NUREG-1950

**Disposition of Public Comments and
Technical Bases for Changes in the
License Renewal Guidance Documents
NUREG-1801 and NUREG-1800**

This document is a knowledge management and knowledge transfer document associated with Revision 2 of NUREG-1801, "Generic Aging Lessons Learned (GALL) Report," and Revision 2 to NUREG-1800, "Standard Review Plan for Review of License Renewal Applications for Nuclear Power Plants." This document updates and combines NUREG-1832, "Analysis of Public Comments on the Revised License Renewal Guidance Documents," and NUREG-1833, "Technical Bases for Revision to the License Renewal Guidance Documents," (both published in 2005) into a single document. The NRC has decided to combine these two documents because their subject matter is so closely related that there was considerable redundancy when they were two separate documents.

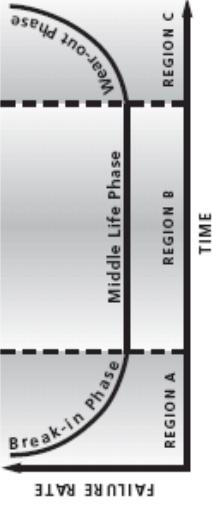
1110	XI.M41 ML102371274, Comment XI.M41-PW22	Detection of Aging Effects Directed Inspections – Buried Pipe - What evidence is there to justify a 10 year interval? This is the crux. One simply cannot squeeze all these situations into the same shoe box. 10 years is too infrequent period – especially in license renewal when components may well be entering the “wear-out” stage (Region C) of the Bath Tub Curve of degradation. Inspection frequencies need to be based on age.	The staff disagrees with this comment. The GALL Report has not been changed.	The 10-year inspection interval is consistent with most inspections contained in ASME Code Section XI. As discussed in the staff response to Comment 1096, the use of the bath tub curve concept is inappropriate for passive components such as piping or tanks. For conditions that are less than optimal, the staff has chosen to increase the extent of inspection rather than the frequency of inspections. Increasing either

Comment Number	Location in Document and Commenter Reference No.	Comment	NRC Disposition	Technical Basis
		<p>Figure 1 The Bathtub Curve</p>  <p>Source: N45.4, 2001.</p>		<p>extent or frequency will accomplish the same goal.</p> <p>The staff finds the commenter's reference to the "bathtub curve" as a model for corrosion failures not applicable. The bathtub curve is used to predict failures of electronic components, which have high failure rates upon startup and at end of life. Corrosion of metals in soils do not have either a high initial failure rate or a sharp increase in failure at the end of their expected lives.</p>
1111	XI.M41 ML102371274, Comment XI.M41-PW23	<p>Detection of Aging Effects</p> <p>(1) If in fact there are various degrees of susceptibility, there should also be varying degrees of inspection frequencies.</p> <p>(2) need a more precise and complete listing of locations more susceptible to degradation – absent from list, for example, are age component, flow rate, elbows, welds</p>	<p>The staff disagrees with this comment. The GALL Report has not been changed.</p>	<p>(1) See the staff response for comment 1110. The 10-year inspection interval is consistent with most inspections contained in ASME Code Section XI. As discussed in the staff response to comment 1110, the use of the bathtub curve concept is inappropriate for passive components such as piping or tanks. For conditions that are less than optimal, the staff has chosen to increase the extent of inspection rather than the frequency of inspections.</p> <p>Increasing either extent or frequency will accomplish the same goal.</p>

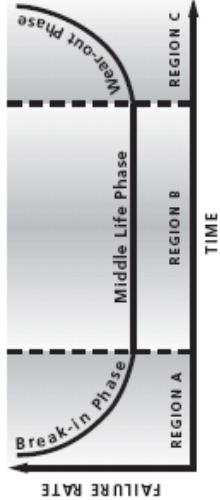
1140	XI.M41 ML102371274, Comment XI.M41-PW46	Detection of Aging Effects Directed Inspections – Buried Tanks - Tanks must include partially buried tanks such as SFP, CST and the drywell (it is a partially buried tank and the SFP is encased below in concrete); and see comments on Table 4C's footnotes	The staff disagrees with this comment. The GALL Report has not been changed.	Buried portions of tanks which are substantially buried are included in this program. Inaccessible portions of tanks which are substantially above ground are covered by the Above Ground Tanks AMP. Accessible portions of both of these types of tanks are covered by the external surfaces monitoring AMP. Structures such as the spent fuel pool and the drywell are not tanks. These structures are covered by the structures monitoring program. Condensate storage tanks are normally

Comment Number	Location in Document and Commenter Reference No.	Comment	NRC Disposition	Technical Basis
1141	XI.M41 ML102371274, Comment XI.M41-PW47	<p>Detection of Aging Effects</p> <p>What evidence is there to justify a 10 year interval. This is the crux. One simply cannot squeeze all these situations into the same shoe box. 10 years is too infrequent a period – especially in license renewal when components may well be entering the “wear-out” stage (Region C) of the Bath Tub Curve of degradation.</p> <p>Figure 1 The Bathtub Curve</p> 	The staff disagrees with this comment. The GALL Report has not been changed.	<p>Please see staff response to comment 1110.</p> <p>The 10-year inspection interval is consistent with most inspections contained in ASME Code Section XI. As discussed in the staff response to comment 12, the use of the bath tub curve concept is inappropriate for passive components such as piping or tanks. For conditions that are less than optimal, the staff has chosen to increase the extent of inspection rather than the frequency of inspections. Increasing either extent or frequency will accomplish the same goal.</p> <p>The staff finds the commenter's reference to the "bath tub curve" as a model for corrosion failures not applicable. The bath tub curve is used to predict failures of electronic components, which have high failure rates upon startup and at end of life. Corrosion of metals in soils do not have either a high initial failure rate or a sharp increase in failure at the end of their expected lives.</p>
